Subject: **Review of Revised Plans**
Proposed New Residence
6950 Southeast Maker Street
Mercer Island, Washington

Subject: **Slope Stability Update**
Proposed New Residence
6950 S.E. Maker Street
Mercer Island, Washington

As a part of the 2207-019-SUB1-PLANS REVIEW by City of Mercer Island, their geotechnical third-party reviewer made the following comment:

Static

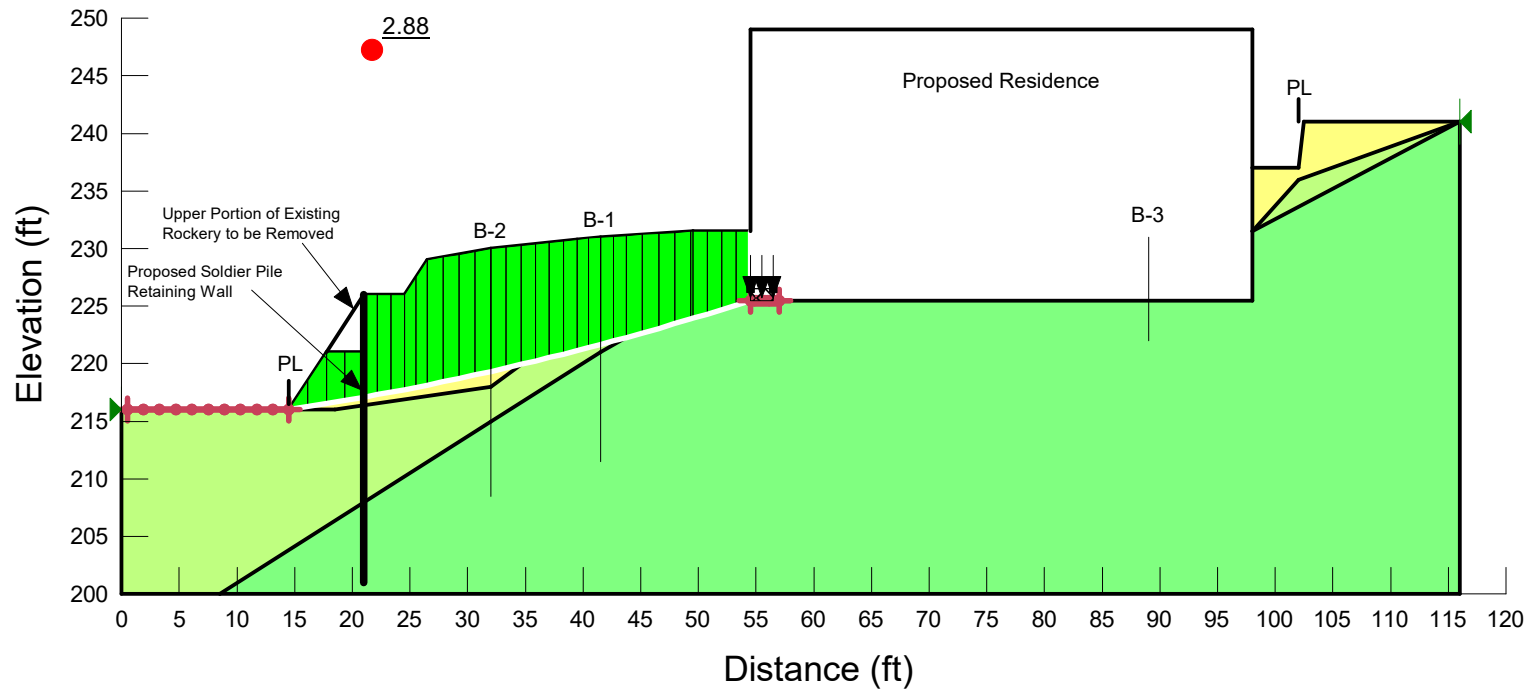
Based on our previous stability assessments, a theoretical failure could have extended through the toe of the existing rockery in the event of the low probability Maximum Considered Earthquake. The stabilization piles should be designed to resist active and seismic earth pressures to that depth, with passive soil pressure in the competent glacial till resisting the lateral earth loads below that depth.

The stabilization wall should be designed for an active soil pressure equal to that pressure exerted by an equivalent fluid with a unit weight of 40 pounds per cubic foot (pcf) if it retains level soil. A seismic surcharge of $8H$ pounds per square foot (psf) should be applied also. In this case H is the effective design retention height, which extends to the base of the existing rockery. An ultimate (no safety factor included) passive soil pressure equal to that pressure exerted by a fluid with a density of 450 pcf will resist the lateral movement of the piles below the stabilization depth. This passive resistance can be assumed to act over twice the width of the wide-flange beams. Typically, a safety factor of 1.5 is applied to the ultimate passive resistance for static conditions, and 1.1 to 1.2 for seismic loading conditions.

F of S: 2.88
